APPLICATION NO.	FILING DATE	FIRST NAMED INVENTOR	ATTORNEY DOCKET NO.	CONFIRMATION NO.
10/690,408	10/21/2003	Nicolay Y. Kovarsky	008451/CMP/ECP	7371
44257	7590	09/20/2006		EXAMINER
PATTERSON & SHERIDAN, LLP 3040 POST OAK BOULEVARD, SUITE 1500 HOUSTON, TX 77056				WILKINS III, HARRY D
			ART UNIT	PAPER NUMBER
			1742

Advisory Action Before the Filing of an Appeal Brief	Application No.	Applicant(s)
	10/690,408	KOVARSKY ET AL.
	Examiner	Art Unit
	Harry D. Wilkins, III	1742

FIG.3

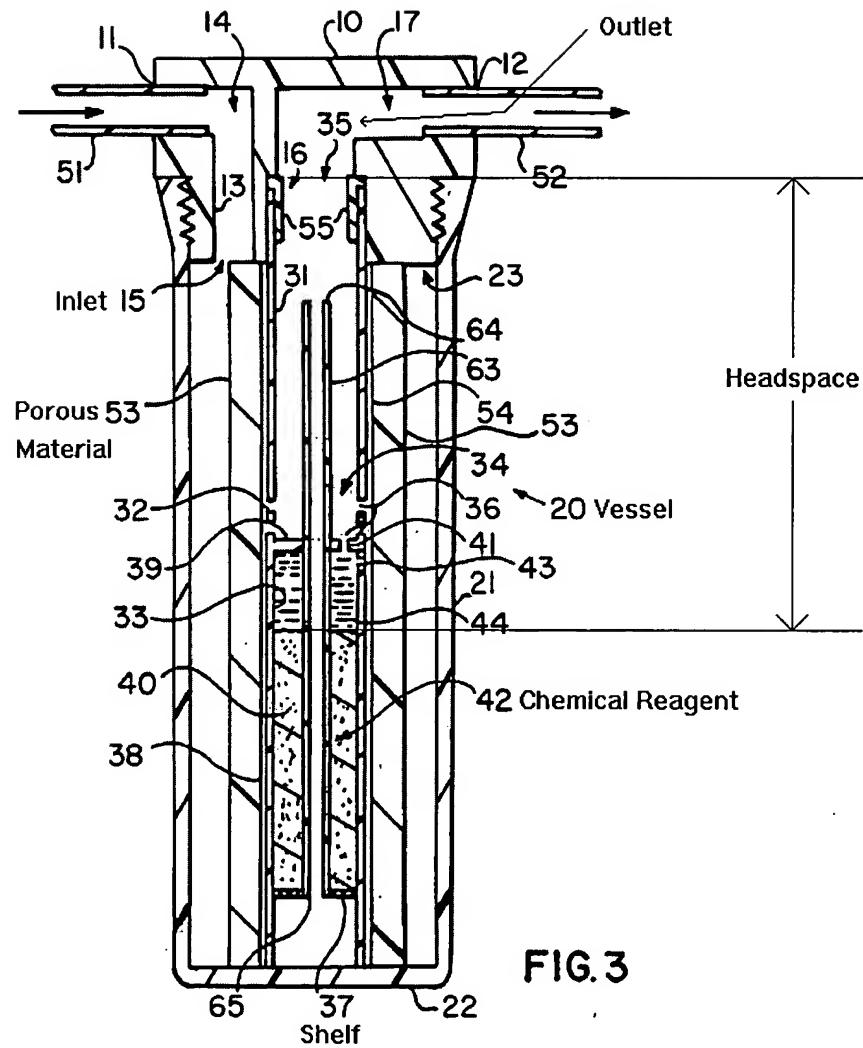
Continuation of 11. does NOT place the application in condition for allowance because: each and every element of the claims is present in the teachings of Brandreth, III, or obvious in view of the teachings of Brandreth as indicated in the final rejection. Attached is figure 3 of Brandreth, III with the Examiner's notations indicating the portions of the structure which read on the claimed elements. The solution flows from the inlet to the outlet through the headspace as indicated
